## SUPPLEMENTAL INFORMATION TO AMENDMENT TO OPERATING LICENSES NPF-4 AND NPF-7 NORTH ANNA POWER STATION UNIT NOS. 1 AND 2

## NORTH ANNA UNIT 2 CYCLE 3 CONSERVATIVE CALCULATION OF ENTHALPY RISE FACTOR WITH POWER LEVEL AND TECHNICAL SPECIFICATION LIMITS

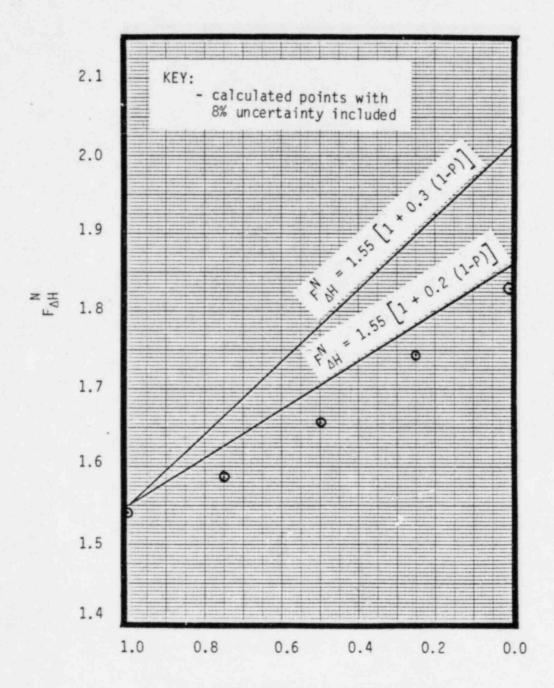
In our letter, dated December 8, 1982, Serial No. 622, Vepco requested a change to the existing  $F_{N}^{N}$  fractional power multiplier for the North Anna Power Station Unit Nos. 1 and 2. The attached Figure 1 provides additional information in support of these proposed changes as requested informally by M. Chatterton of the Nuclear Regulatory Commission staff during a March 15, 1983, telephone conversation. Figure 1 shows the calculation of FNH versus power level for North Anna Unit 2 Cycle 3 compared to the current and proposed Technical Specification limits on FNH .
